**SUBJECT: THREE MILE ISLAND STATION, UNIT 1 – NRC INTEGRATED  
INSPECTION REPORT 05000289/2014004**

Report No: 05000289/2014004

Facility: Three Mile Island Station, Unit 1

**Figure 2: Profile Results for Indications Greater Than 1 Inch Total Length**

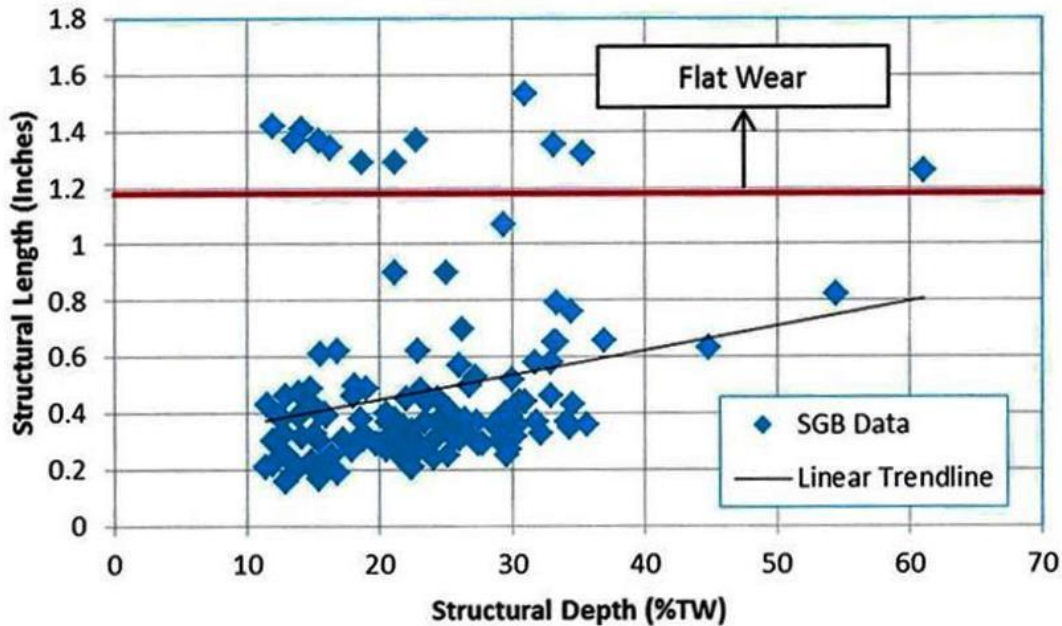
**Observation #5** - A possible problem with the OA methodology may be the treatment of structural depth and structural length as totally independent parameters (if this is what was done (see question 8)). The inspection data needs to be evaluated for any bias of longer structural lengths to the deepest flaws.

In order to illustrate the effect that the shallow tapered indications have on this correlation, another curve was generated which includes only those profiled indications with total measured lengths greater than 1 inch. Applying this criterion effectively eliminates the shallow tapered indications since tapered flaws would need to grow to a relatively deep depth before they would reach a length of 1 inch. This relationship is shown in **Figure 2** as shown in the figure; there is no correlation of increasing structural length with increasing structural depth. Hence, for the flaws of most concern (flat or tapered and relatively deep), there is no correlation between structural length and structural depth.

**Figure 1: All Profile Results for SGB**

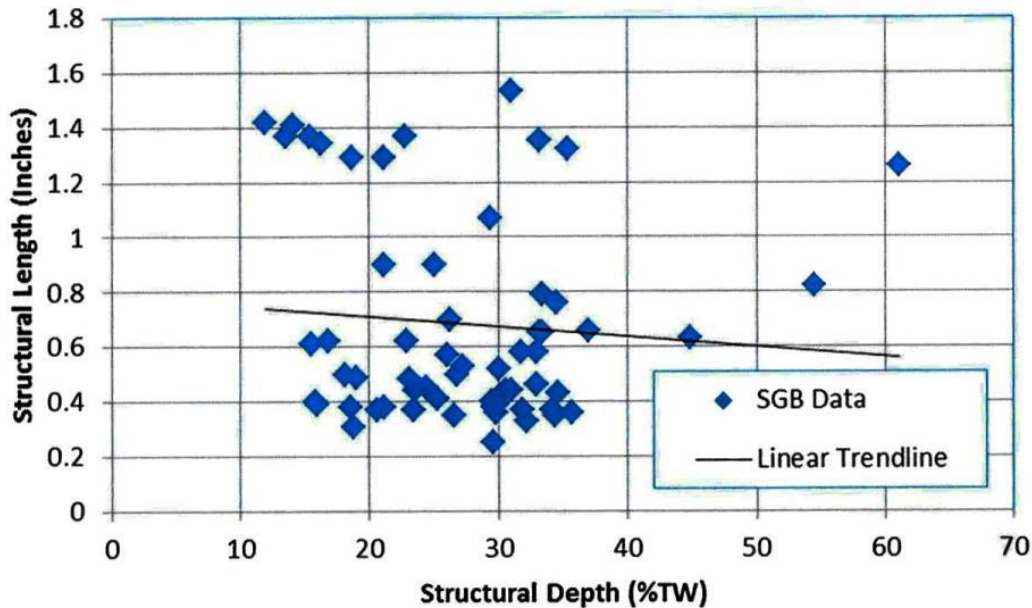
**Question 9** - Was the eddy current data reviewed to establish whether or not larger structural lengths are biased toward being associated with deeper flaws? If so, what trends were observed?

Yes, there is a correlation between structural length and structural depth. However, this correlation is driven primarily by the shallow, tapered indications. To support the response to this question, additional line-by-line sizing was performed. This additional line-by-line sizing was focused on indications that the resolution analysts deemed to be flat as well as relatively shallow, tapered indications. This was done to complement the sizing that was performed during the outage which focused primarily on the deepest indications.

**Figure 1** below shows the structural length plotted against structural depth for all profiled indications in SG B. As shown in the figure, there were twelve indications that were clearly flat as evidenced by a structural length greater than 1.2". Eleven of these twelve indications had structural depths less than 40%TW and six of these indications had structural depths less than 20%TW.

**As shown in Figure 1**, there is some correlation between structural length and structural depth. However, as previously mentioned, this correlation is primarily driven by the shallow, tapered indications. When a tapered flaw first initiates, it will only be present at one edge of the support and may only have a total length of 0.4", for example. Obviously, if the total length is 0.4" and the flaw is tapered, its structural length will be less than 0.4". As the flaw grows in depth, its total length and structural length will increase provided the taper angle remains the same. This is the primary reason that there is an apparent relationship between structural length and depth.
